Date: January 29, 2015

**Comment for the Draft Desert Renewable Energy Conservation Plan (DRECP)
and
Environmental Impact Report/Environmental Impact Statement (EIR/EIS)**

DRECP Land Coverage and Wind Areas

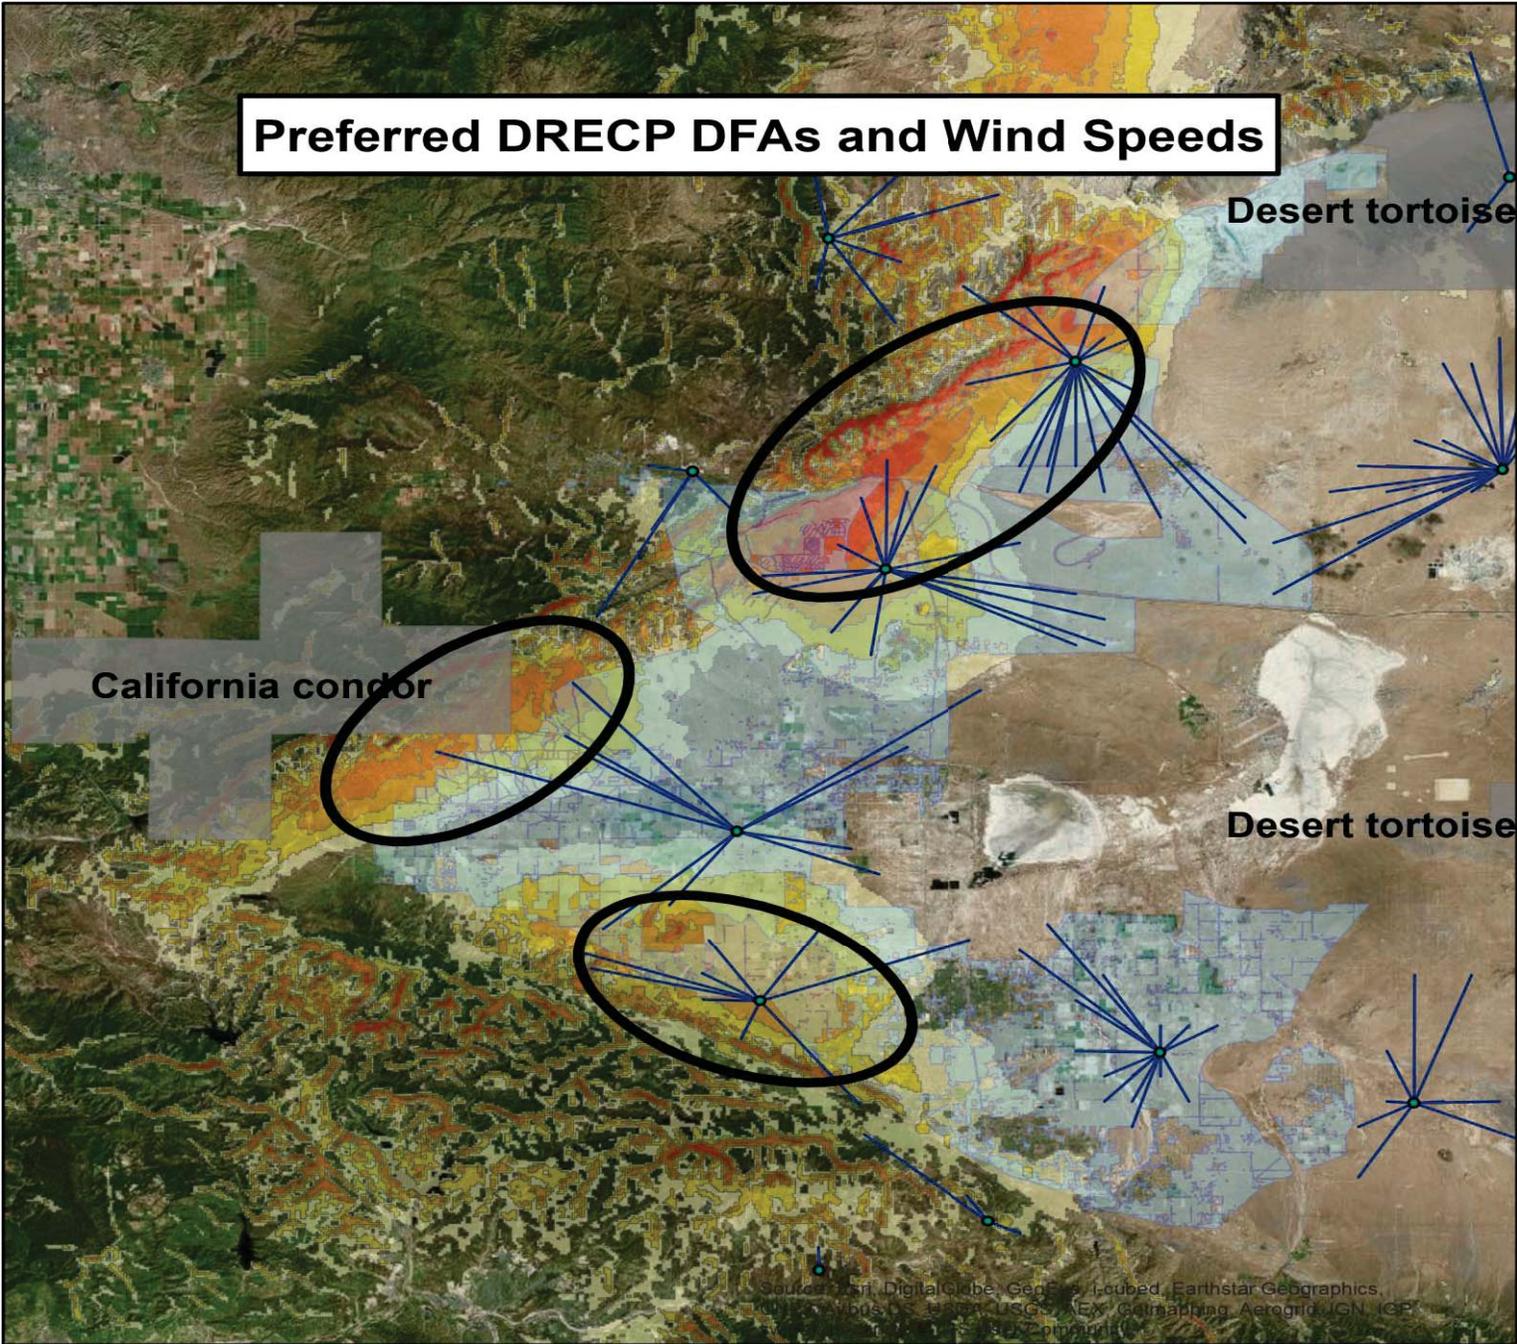
In this map, all within the dark gray areas are under the DRECP. However, within them, there are various good wind resource areas highlighted with magenta rectangles, but not labeled as DFAs. Southern California has very limited wind resources so we should not forego possible development in these marked areas, especially the general San Bernardino county desert area. We developers see the potential of new projects with already installed transmission lines around these marked areas. San Bernardino has not tried to push for any new projects for years due to eagles in the area, even in the incredible wind resource in Apple Valley (light blue circle). Still, just like the condor issue in Kern County, there are various mitigation efforts to keep the eagles safe from harm. Other than these areas, there is very little or weak wind resource in California. If DRECP can lend a helping hand in allowing more wind farm development areas, including special attention to Apple Valley's high wind resource, then more wind projects will be constructed to ensure a better future for all of us.

Preferred DRECP DFAs and Wind Speeds

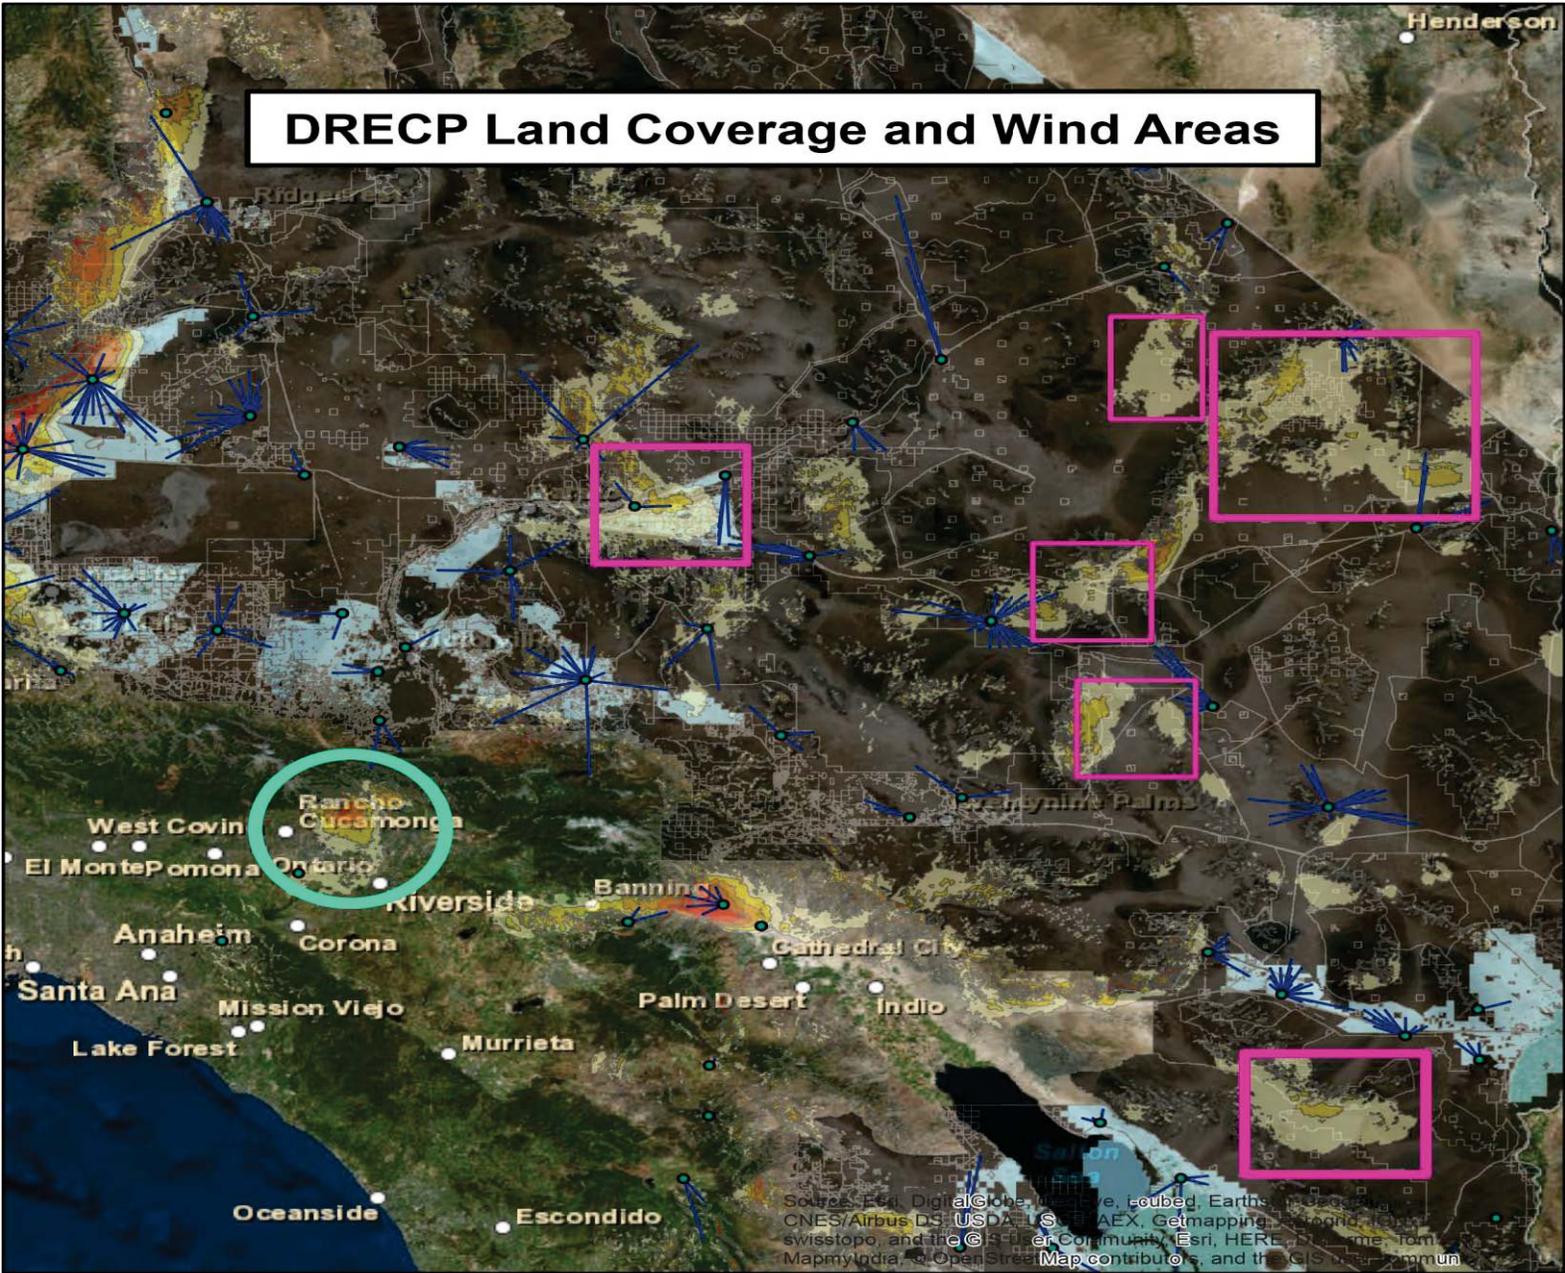
Attached are two PDF files with specific examples that prove the points made above.
DRECP DFAs for Wind
Within the black rings are high wind speeds for potentially successful wind projects. This land is part of DRECP's preferred land plan as DFAs, yet development of projects too close to the mountains incurs stunningly high costs, and county officials disallow any project near the condors due to concerns with Fish and Wildlife Services. Even with substantial spacing away from the condor areas, wind projects will either be shut down by the county without ample spacing, or be moved further away and, by doing so, lose any economic viability remaining from the vastly weaker wind speeds. The top right ring involves BLM land as well as established wind turbines. The bottom ring is within LA County, which involve solar farms, residential buildings, and protected conservation lands. Kern county officials have expressed interest in renewable energy projects, but without DRECP's intervention, development of renewable energy projects and improvement of surrounding economies cannot happen.
